SUBJECT: Removal Action Report for the 484-17D Coal Storage Area (U) (SRNS-RP-2022-00071, Revision 1, November 2022) (Redline and Clean Copies) and Savannah River Site's Responses to the Regulatory Comments on the Revision 0 Document, SEMS Number: 63

**SRS Responses to EPA Comments on the
Removal Action Report for the 484-17-D Coal Storage Area
SEMS #63, SRNS-RP-2022-00071, Revision 0, June 2022
Savannah River Site, South Carolina**

**SRS Responses to South Carolina Department of Health and Environmental Control
Comments on the
Removal Action Report for the 484-17D Coal Storage Area (U)
SRNS-RP-2022-00071, Revision 0, June 2022, SEMS No: 63**

Revised Figure 6

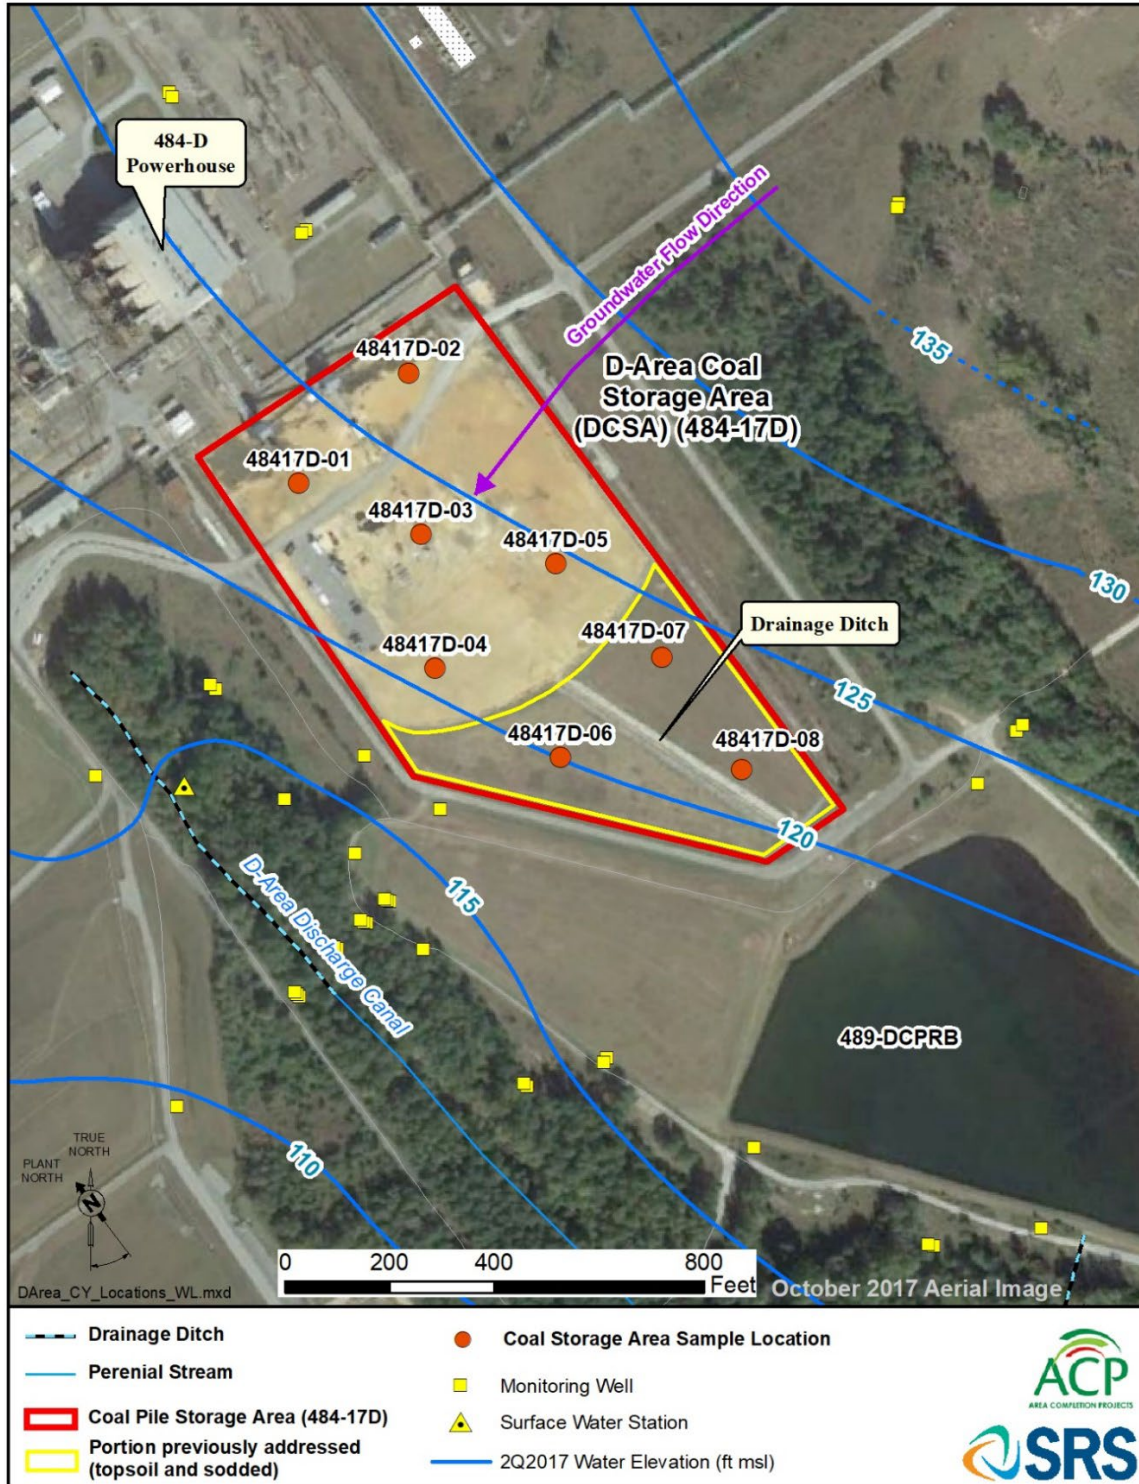
4. **Figure 6. June 2018 and May 2022 Soil Sampling Locations within the 484-17D DCSA:**
Please ensure that the figure legend outline color (purple) for the Coal Pile Storage Area (484-17D) matches the figure outline for referenced area (red in figure).

Figure 6 will be revised so the legend and figure both show the Coal Pile Storage Area (484-17D) in a red outline, as indicated by the attached revised Figure 6.

**APPENDIX E-1.
072720 Topographical As-built Drawing of 484-17D DCSA Northern Portion
September 15, 2020**

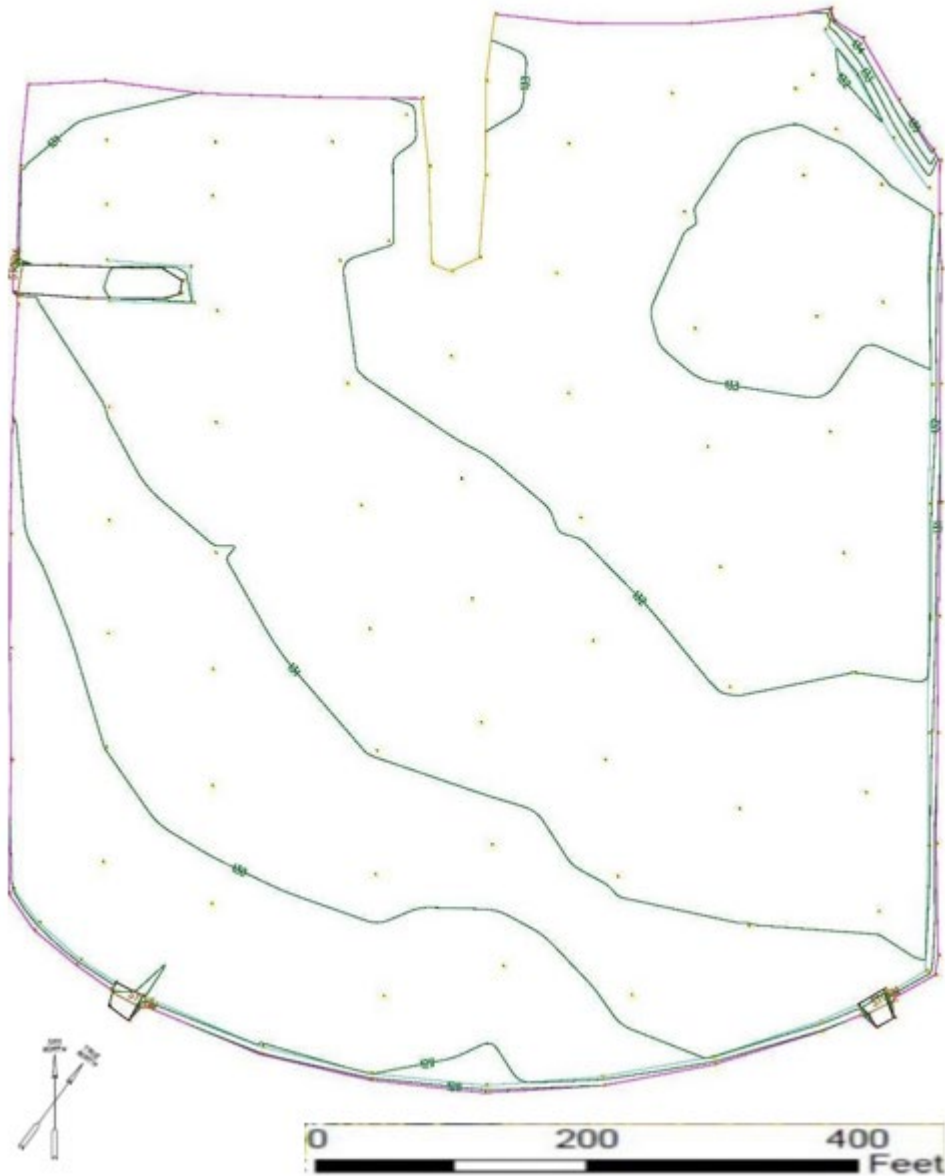
6. Appendix E-1, 072720 Topographical As-built Drawing of 484-17D DCSA Northern Portion, September 15, 2020, page E-3. Please add a north arrow and scale bar to the figure.

Appendix E-1, 072720 Topographical As-built Drawing of 484-17D DCSA Northern Portion will be revised to include a north arrow and scale as follows:

**APPENDIX E-2.
093520 Topographical As-built Drawing of 484-17D DCSA Southern Portion
October 1, 2020**

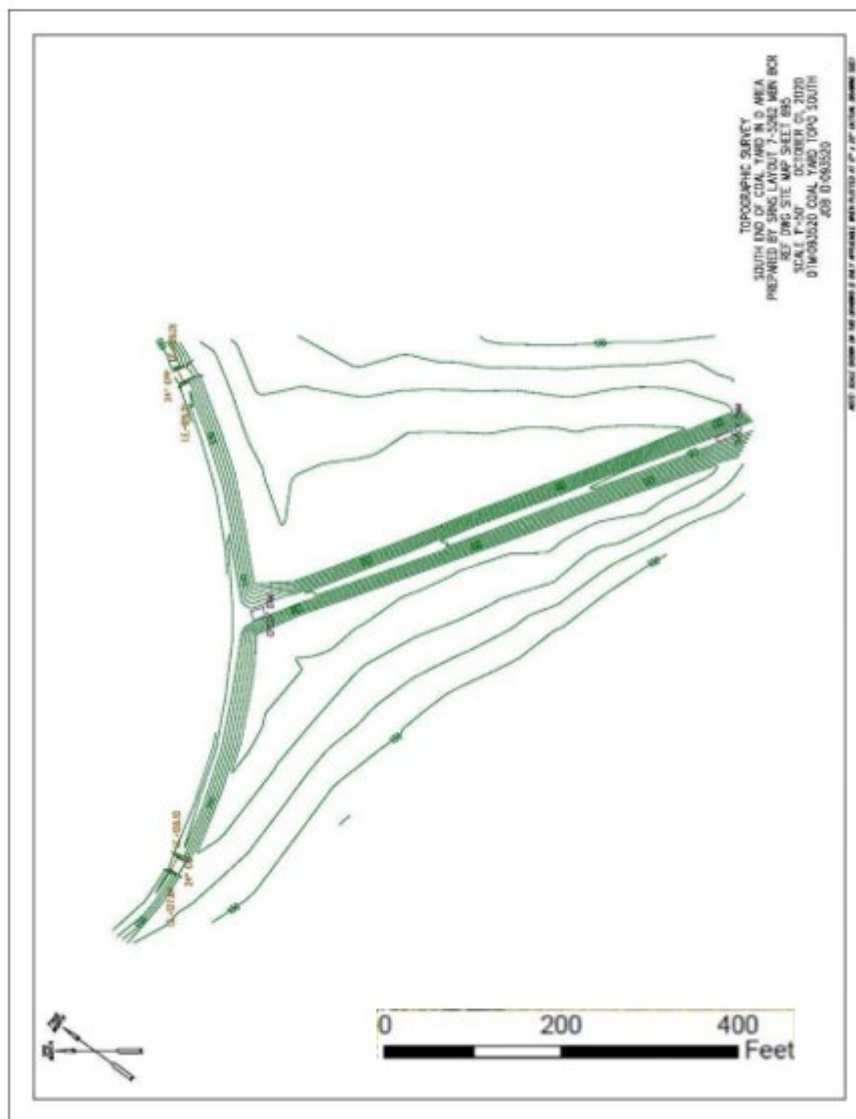
7. Appendix E-1, 093520 Topographical As-built Drawing of 484-17D DCSA Southern Portion October 1, 2020. Please add a scale bar to the figure.
-

Appendix E-1, 093520 Topographical As-built Drawing of 484-17D DCSA Southern Portion will be revised to include a scale as follows:
